Village of Arlington Heights Building & Life Safety Department

To: Sam Hubbard, Development Planner, Planning and Community Development
From: Deb Pierce, Plan Reviewer, Building & Life Safety Department
Subject: 3400 W Euclid Ave – PUD Amendment, Prelim/Final Plat of Subdivision, Land Use Variation to allow residential uses below the 1st floor in the B-2 District
PC#: 18-010 – Round 1
Date: April 17, 2018

PLAN COMMISSION PC #18-010
Arlington Downs Phase 2
3400 W. Euclid Ave.
PUD Amendment, Pre/Final Plat of Subdivision, LUV
Round 1

FIRE ENGINE TURNING TEMPLATE

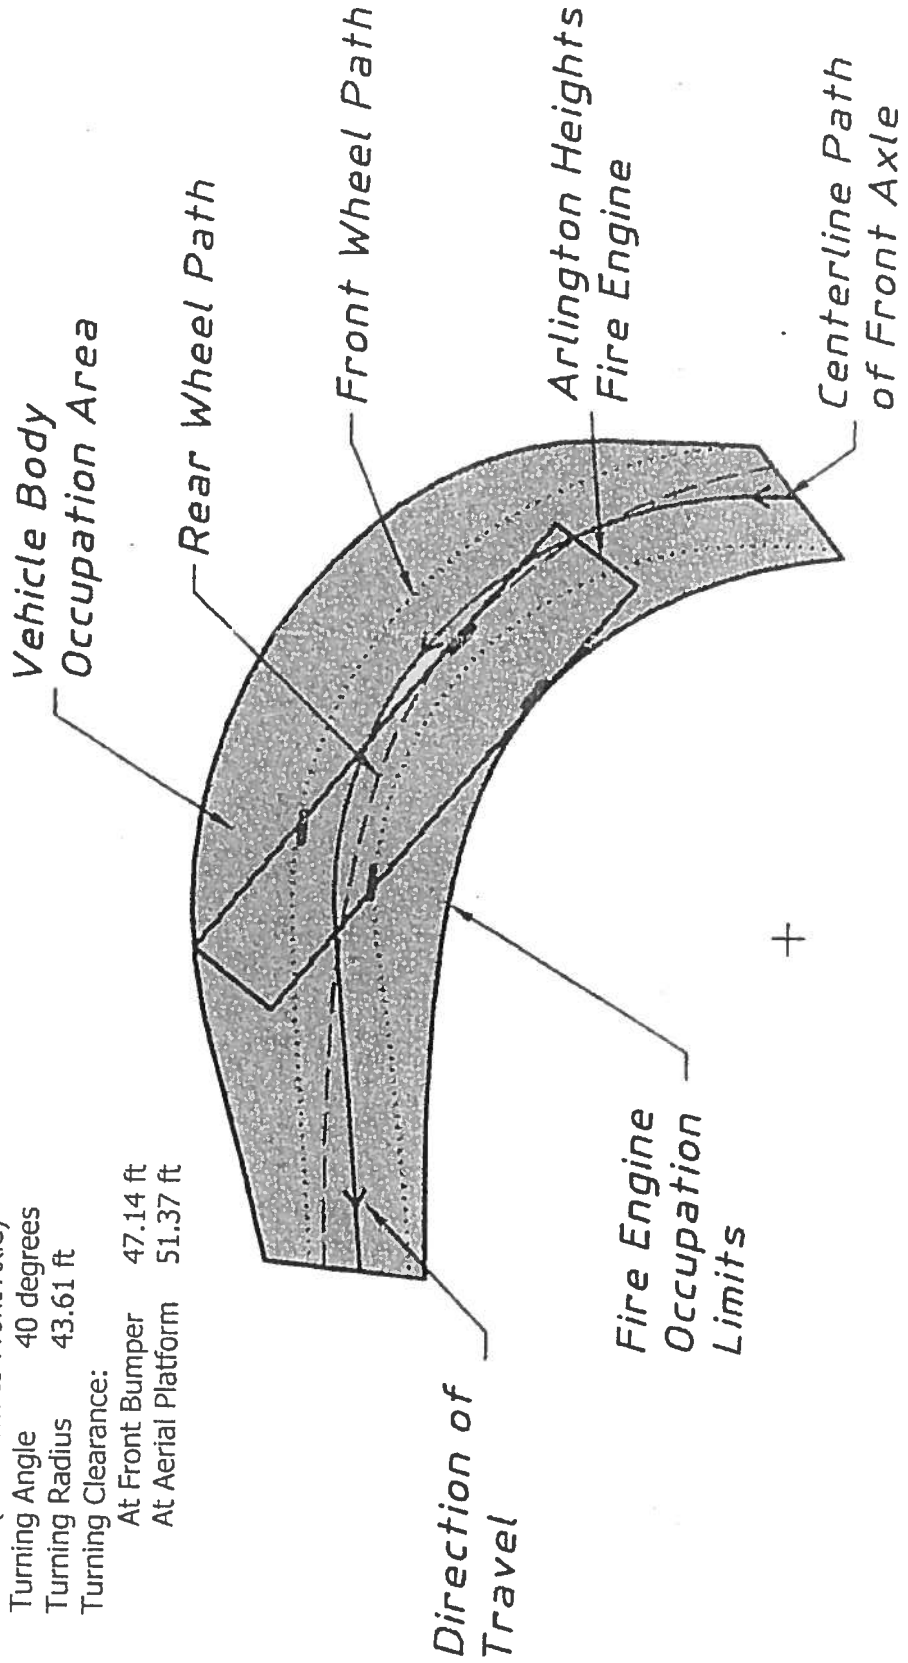
18. Provide an exhibit to engineering scale showing the turning path of the Fire Department's responding vehicle, in this case the tower truck. Exhibit must show front and rear wheel paths and the extent of the front and rear overhangs, as provided in an "Autoturn" exhibit. The vehicle shall be shown maneuvering through the site in all possible directions of travel. Attached are the specifications for the tower apparatus.
19. Fire lanes adjacent to buildings must have a minimum pavement width as directed by the Fire Department to accommodate the tower truck's outriggers. Fire lanes require a heavy-duty pavement section. Asphalt pavement section to consist of: 2" Surface, 2-1/4" N-50 Binder, 5" N-50 Binder, and 4" CA-6 Stone Subbase. Concrete driveway apron to be 8" thick.
